## HOWARD COUNTY HISTORIC PRESERVATION COMMISSION

### May Minutes

Thursday, May 7, 2020; 7:00 p.m.

Figure 8 - Site layout

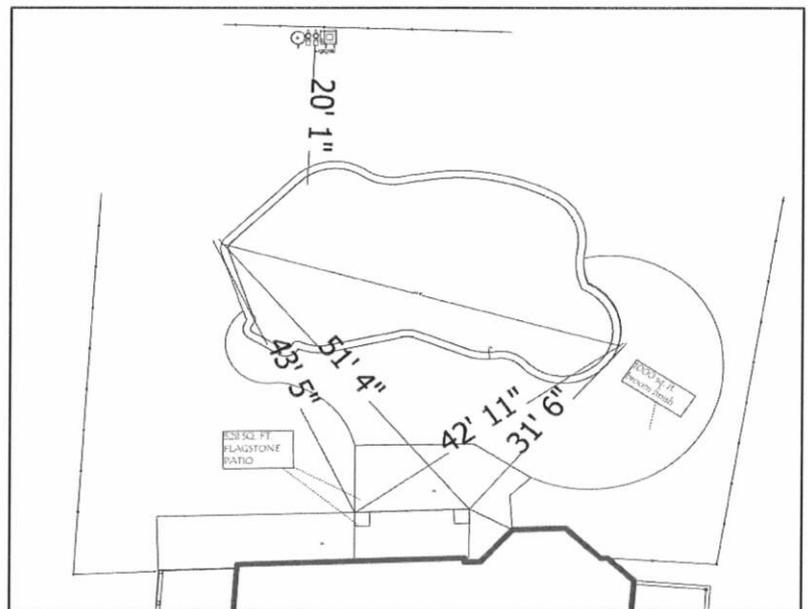
The proposed concrete and flagstone patios comply with the Commission’s recommendations from the December meeting to have a historically appropriate patio adjacent to the historic house and the concrete patio adjacent only to the pool. Neither patio will be highly visible, if visible at all, from Old Lawyers Hill Road due to the change in topography, and location on the rear of the house.

Figure 11 - Installed tables and chairs

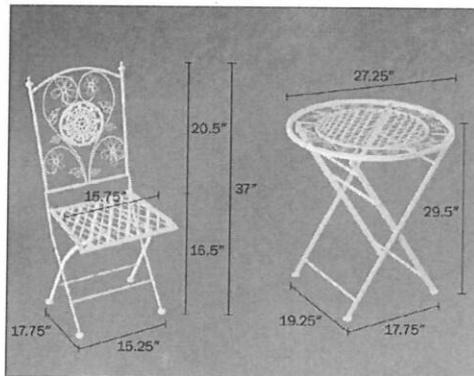
Ms. Tennor said she agreed with the staff that the white metal furniture is different from what the Commission sees outside of the streetscape in Ellicott City. Ms. Tennor noted all other street furniture is black and the application was asking for white street furniture. Ms. Tennor said she does not object to it strongly enough to have the chairs modified. Ms. Tennor asked if the street furniture has already been installed. Ms. Porter confirmed the street furniture had already been installed. Ms. Tennor said while the light fixtures are black and the furniture is white, she thinks there has been a great improvement to the property and does not object to the work but stated it is very different.

Mr. Roth said quoting the Guidelines "use simple designs such as wood or dark metal." Mr. Roth noted that while the Guidelines say wood and dark metal, these are an example not a requirement of material. Mr. Roth said the question is whether this furniture painted off white can be considered traditional. Mr. Roth said he thinks the color is okay, the chairs are a traditional material and the color is simple in design. Mr. Roth said he is okay with the application.

Ms. Zoren said the application is a little bit different than the rest of Ellicott City and the property in question is a unique space to Ellicott City. The request is a traditional material and moveable furniture not permanently affixed. Ms. Zoren said she is okay with the application.

Figure 14 - Proposed scoring pattern

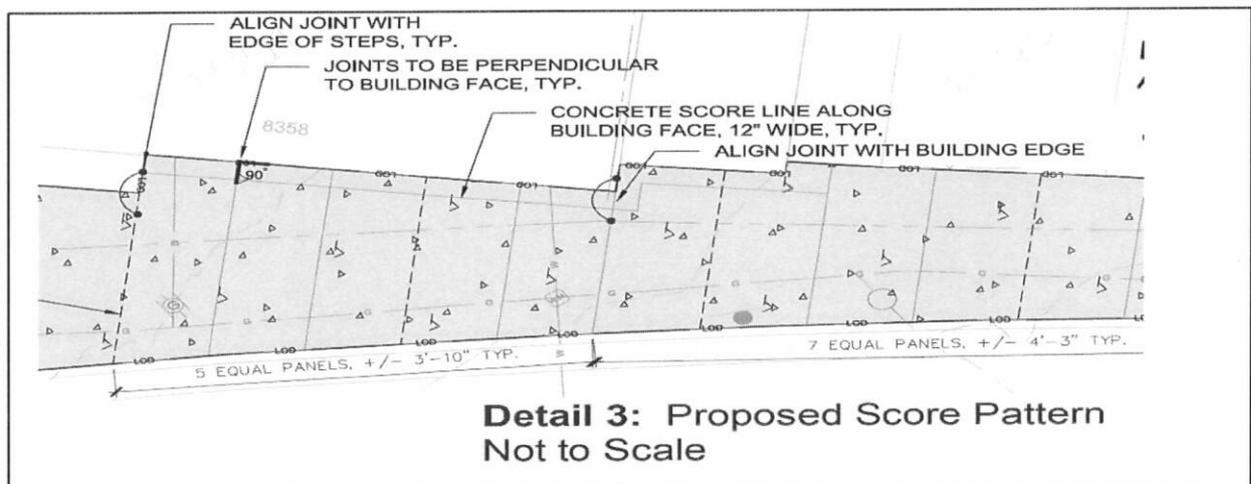
Ms. Tennor said she thought the submittal was a good response from all the comments the Commission made from HPC-19-34. Ms. Tennor said the request was valid and good with organizing the streetscape as Mr. Hollenbeck did in the application. Ms. Tennor appreciated the continuation of the gray colored concrete.

Mr. Roth said that he is in support of concrete and brick replacement but wanted to make it explicitly clear behind his reasoning for it. Mr. Roth said in his opinion the Guidelines say that the Commission should be moving toward brick sidewalks and that should be enforced except in substantial situations. Where brick washed out in the flood and modeling shows shear forces were more than the bricks could handle, it is acceptable to replace brick with concrete. Mr. Roth said he is only supportive of the application request because of the safety; using brick in areas that washed out is not appropriate due to the shear stress but in any other situation the sidewalk should be replaced with brick material as the Guidelines state.

Mr. Reich said the Commission has spent a lot of time reviewing sidewalk material in previous hearings. Mr. Reich said the concrete is really a temporary measure until all flood mitigations are put in place. Mr. Reich said in his opinion the Commission is approving this application as a temporary measure to replace the asphalt. Mr. Reich said the pedestrian crossings are a good idea, but he had not considered Mr. Roth's comments about the cyclists. Mr. Reich asked if there were two crossings being installed.

Mr. Hollenbeck clarified that there was an existing crossing at La Palapa's as a precedent for DPW to request a second crossing be installed by Caplan's. Mr. Reich asked what the green line on the plan depicted. Mr. Hollenbeck said that the green line is a depiction of the proposed pedestrian crossing location and what it would look like. Mr. Reich said he was okay with the entire application.

Ms. Zoren said the proposed application is a much more unified streetscape plan than the HPC-19-34 request. Ms. Zoren said she is glad the County is moving away from asphalt patches and the use of concrete in the designated locations due to the force of water is appropriate in the proposed locations.

Figure 21 -- Red lines indicates wall that was already re-aligned and rebuilt (for retroactive approval). Blue dashed line shows remainder to be completed (requires approval).

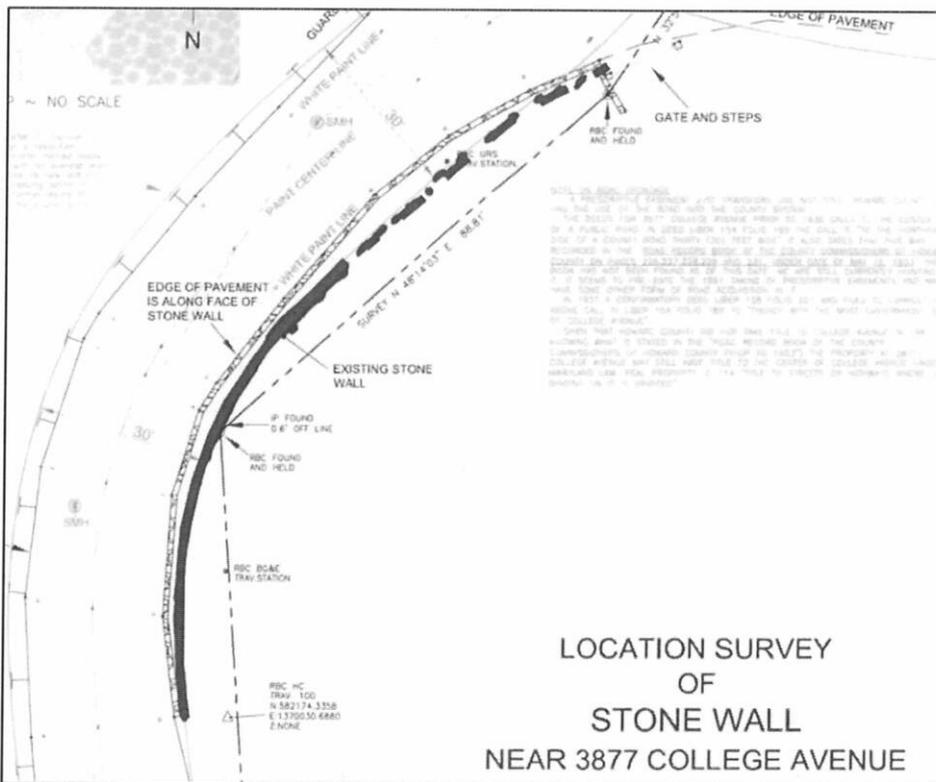
Mr. Roth said he felt that the application was appalling and that he was not going to vote to remove the trees or vote to move anymore wall from the historic context. People drive wild and it is the County that has not added traffic calming measures and that does not justify moving a historic wall out of its context or removing healthy trees. Mr. Roth said it was very regrettable for moving the wall already. Mr. Roth will approve what has been moved but will not approve any more of the relocation of the wall. Mr. Smith said that the County looked at the traffic patterns and were afraid that cars would become

Ms. Zoren said she is inclined to agree with Mr. Roth. Ms. Zoren said as Mr. Smith pointed out, this was one of the last walls of its type in that condition in Ellicott City. Ms. Zoren commended the applicants for repairing the wall with historically appropriate materials. Ms. Zoren said the trees in question are really part of the District and planted in a historic pattern and layout. Ms. Zoren said she would like for the applicant to consult with a tree preservationist or a tree expert. Ms. Zoren noted that the applicant is talking about moving the wall 2-3 feet and explained that if less than 25% of the tree's roots were disturbed, the tree can survive if the roots are trenched properly. Ms. Zoren asked if the project could move the wall in while keeping the oak trees and said that she would like to see the applicant explore that option.

Mr. Shad said as far as the retroactive approval aspect, he understands why the application had to be done that way. Mr. Shad said he agrees with Ms. Zoren's comments about the repairs made to the walls. Mr. Shad said he would hate to see the trees go but knows if the trees become a hazard to traffic, they are going to come down naturally or another way. Mr. Shad said he is okay with the trees being removed and hopefully new trees can be planted on the property for mitigation.

Ms. Tennor added to the motion to complete the proposed realignment of the wall and approve the tree removal with the stipulation that the applicant come back with a planting plan to mitigate the trees removed. Mr. Reich seconded. The motion was approved 3 to 2, Mr. Roth and Ms. Zoren opposed.

Figure 23 - Proposed site layout

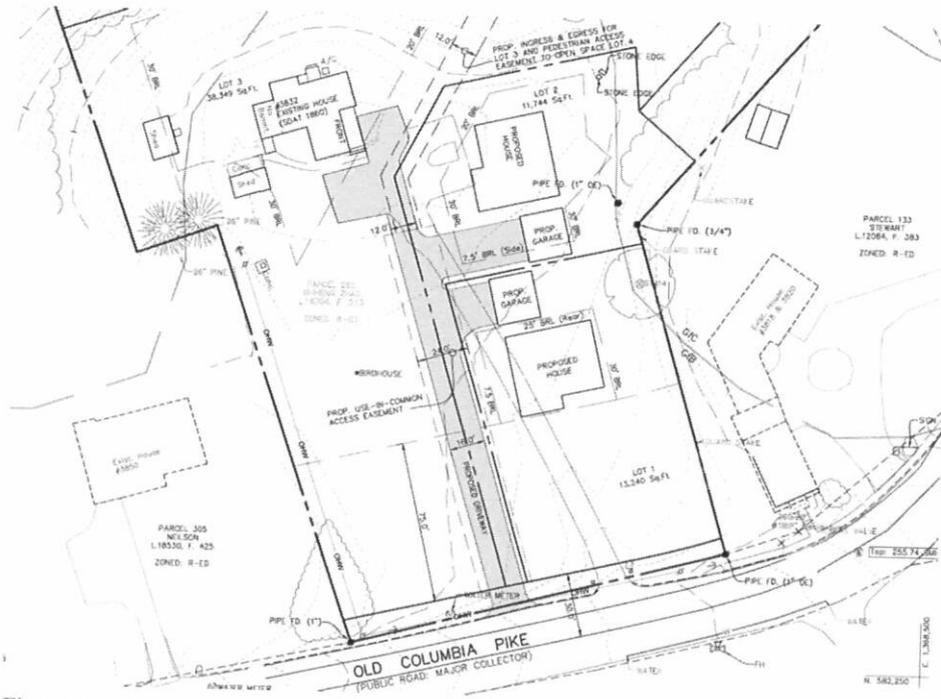
Mr. Roth said he thinks this plan is way better than the frontloading houses that were previously shown. Mr. Roth continued the house nearest to the road mirrors the road and is appropriate with the garage behind it and the second house in the back is appropriate use of space. Mr. Roth said he is okay with the application.

Ms. Zoren asked if the parking pad in front of the historic house was existing. Ms. Tuite said the parking pad was existing and that in front of lot 2, some of the gray space [asphalt parking] had been removed. Ms. Tuite explained that currently it is all paving and that the plan is going to remove a section of the paving and everything shown on the drawing is existing. Ms. Zoren said she felt the parking pad, having cars in front of the historic house, was the only thing lacking with the application but noted the parking pad was existing. Ms. Zoren said she agrees with the landscape buffer between the existing house and new houses. Ms. Zoren said otherwise she thinks the plan is a good solution.

Ms. Tuite said she had no further comments or questions. Ms. Tennor asked why the new driveway appears so much wider than the existing one and asked if it was a zoning requirement for a shared driveway. Ms. Tuite said it was a subdivision requirement when there is more than one lot, a 16-foot wide driveway is required; the driveway width currently is only 8-feet which is not even standard for one house. The driveway as it is, is still a little narrow for two cars to pass.
